U.S. Department Of Transportation Federal Highway Administration

September 18, 1996

Refer to: HNG-14/SS-68

Geometric and Safety Design Acceptance Letter SS-68

Figure 3. Details of the triangular multi-directional slip base assembly.

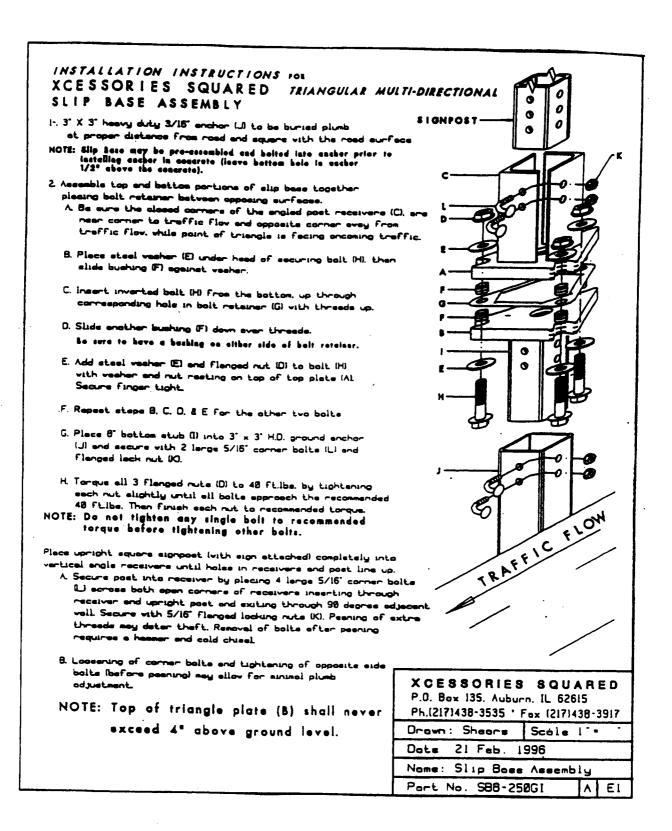
Drawings of the hardware are enclosed. The triangular slip plates were plasma cut from 19-mm (3/4-inch) ASTM A36/ASME SA36 40-50 carbon steel before notching and debarring of the three points. The angle sections were then welded vertically to the plate facing each other. The foundation conditions of the tested hardware differed from those

The results of this modified test met the change-in-velocity and stub-height requirements adopted by the FHWA. Your company's three bolt slip-base for use with a single 63.5 mm square, 12 gauge perforated steel tube sign support, with soil plate, is therefore acceptable for use in standard soil on projects on the National Highway Systems where breakaway systems are required if proposed by a State. The base may also be used with other configurations of single square steel tube posts provided that the section modulus of the support is similar to or greater than that of the tested post. Because a similar base was tested with a concrete foundation with acceptable results, your company's base may also be used when the stub is set in a 760-mm deep concrete foundation with a minimum diameter of 200 mm.

Figure 4. Details of winged anchor.

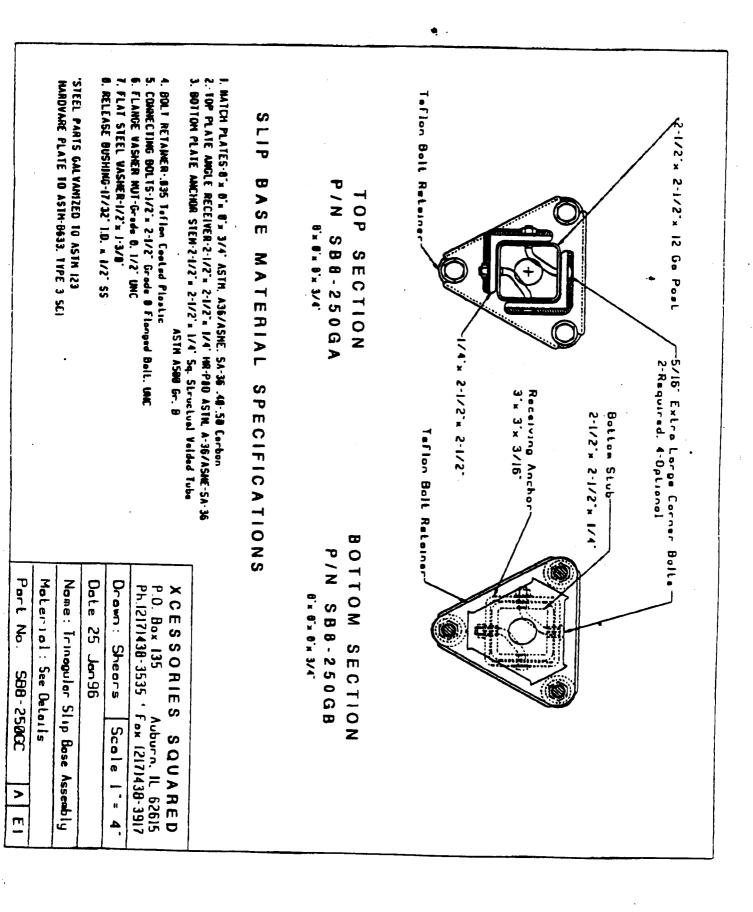
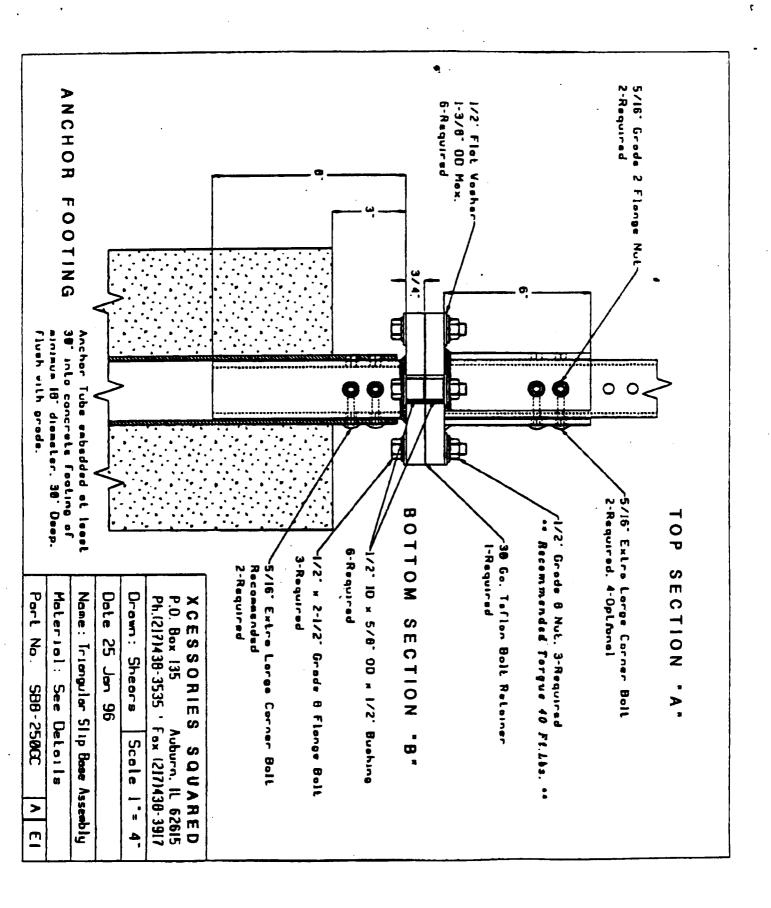
shown in that the "winged anchor" soil plate was used in lieu of the concrete foundation illustrated
